DRAINAGE LETTER

Woodmen Frontage Road Turn Lane

Bent Grass Meadows Drive & East Woodmen
Road

Drainage Letter_V3.pdf Markup Summary 5-17-2022

EXISTING DRAINAGE MAP
SCALE: 1"=40'

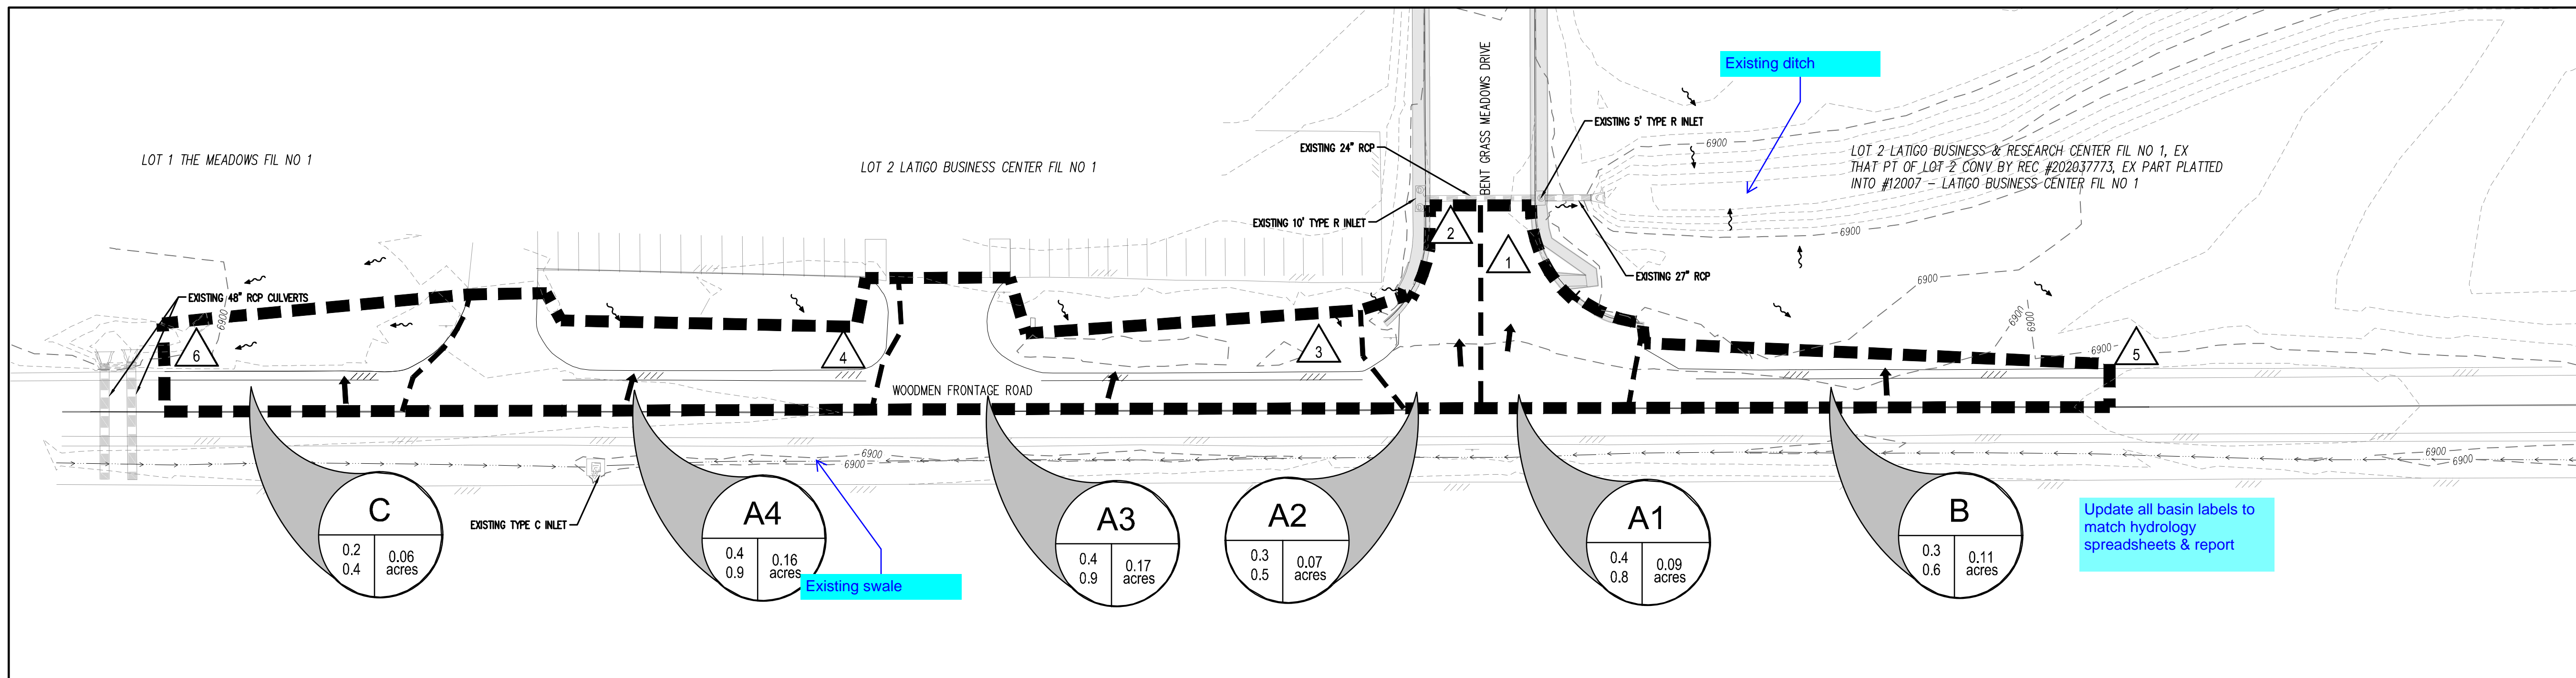
Existing ditch

Update all basin labels to match hydrology spreadsheets & report

Existing swale

Existing culverts

Existing swale

Existing inlet

Label HP

PROPOSED DRAINAGE MAP
SCALE: 1"=40'

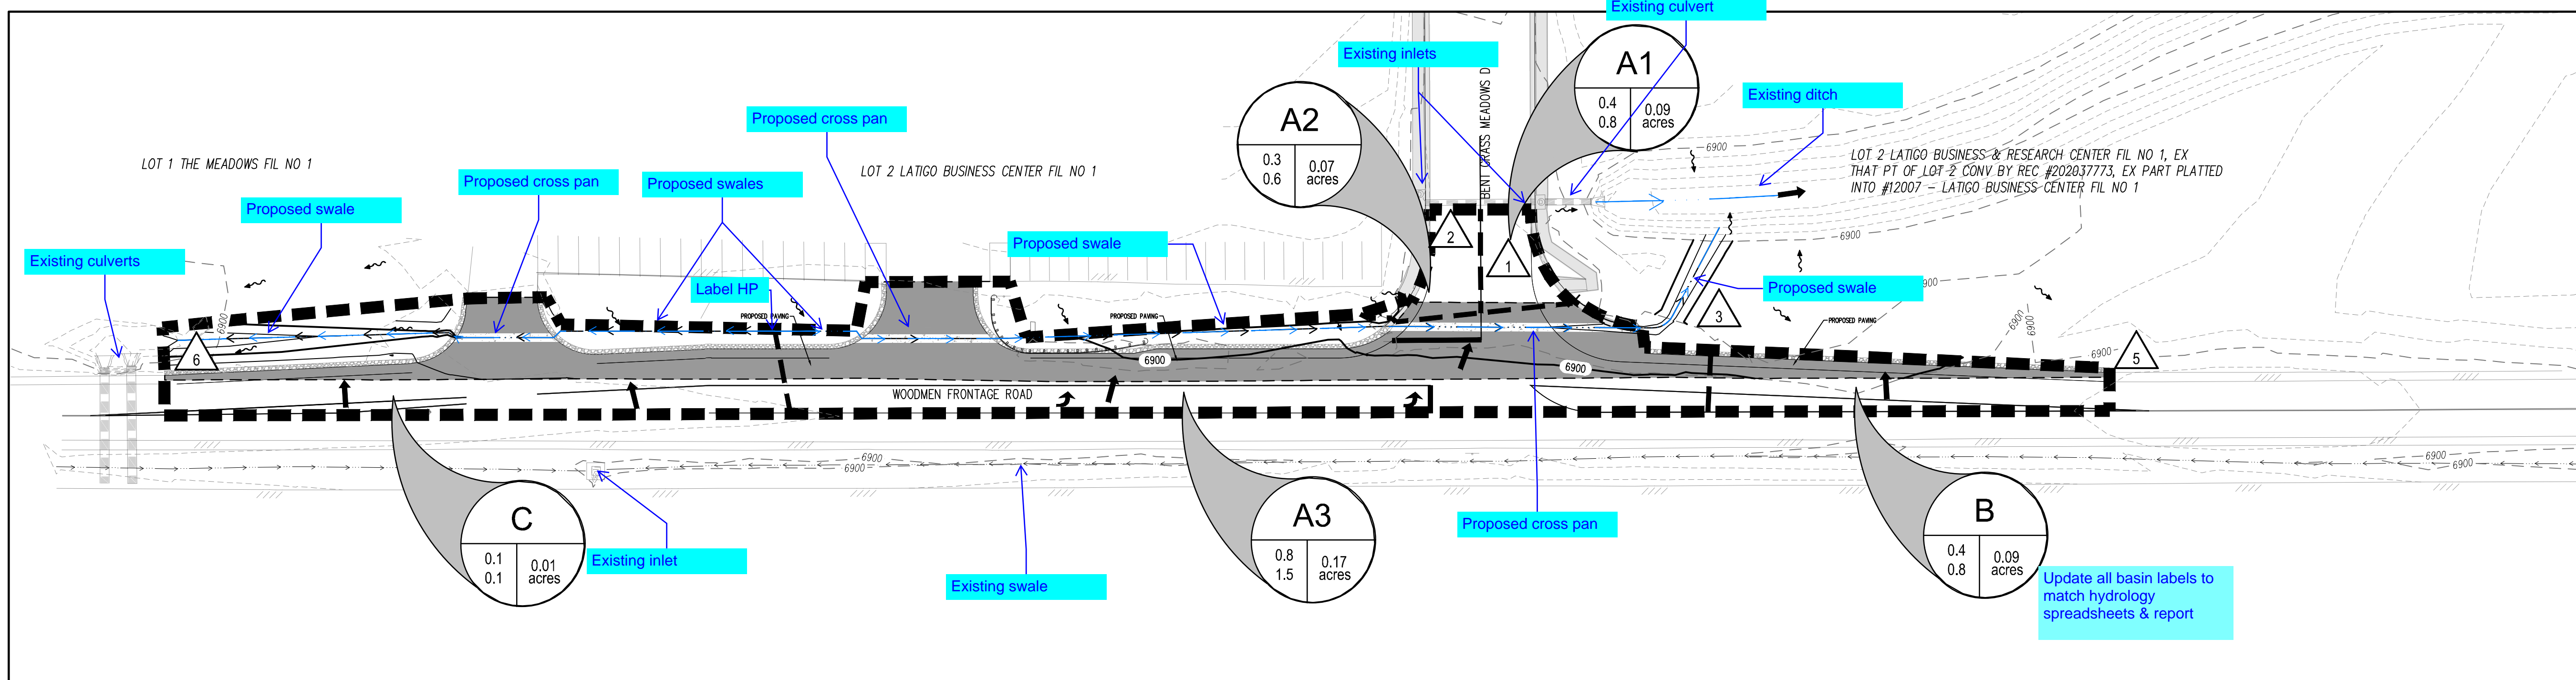
Proposed swale

Proposed cross pan

Proposed swales

Proposed cross pan

Proposed swale

Proposed cross pan

Existing inlets

Update all basin labels to match hydrology
spreadsheets & report

Existing culvert
